SERVICE BULLETIN NO. 42

SUBJECT: Replacement of exhaust muffler inner casing part No. 42339/1 by modified type part No. 42339/2 from which baffles have been deleted. MOD B 161.

SUBJECT: BATTERY RELAY, PART NO. REL 1 - 2. (MOD. B 167)

SUBJECT: Carbon Monoxide Contamination - Cabin (Victa Mods. B117, B124, B132.)

FIG 1.

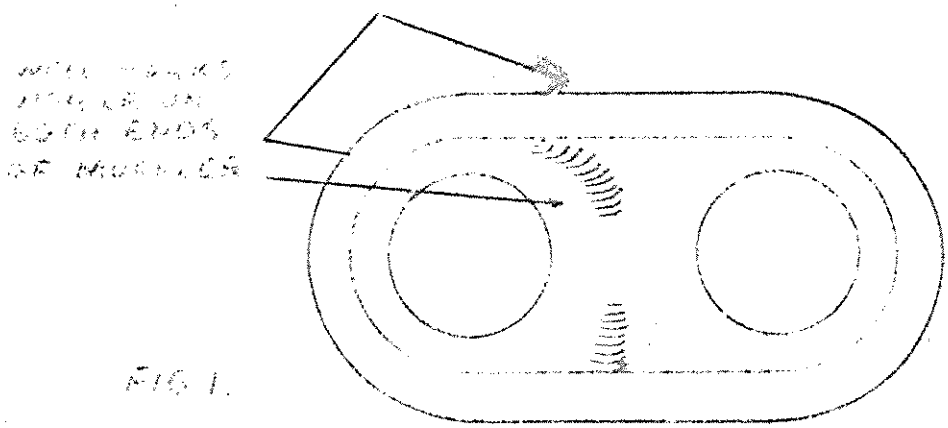
PURPOSE: To obviate possible engine mal functioning due to portion of baffle obstructing exhaust outlet.

REASON: Cases have occurred of baffles cracking and becoming loose.

NOTE: Positive identification of inner casing part No. 42339/1 may be made whilst installed on engine by inspecting end of muffler assembly. Mufflers which have weld marks as shown in Fig. 1 incorporate baffles. If no such weld marks are evident the inner casing conforms to the latest type Part No. 42339/2 and this service bulletin is not applicable.

(6) Remove front and rear covers from muffler assembly and discard inner casing part No. 42339/1.

(7) Reassemble front and rear covers on new inner casing part No. 42339/2.
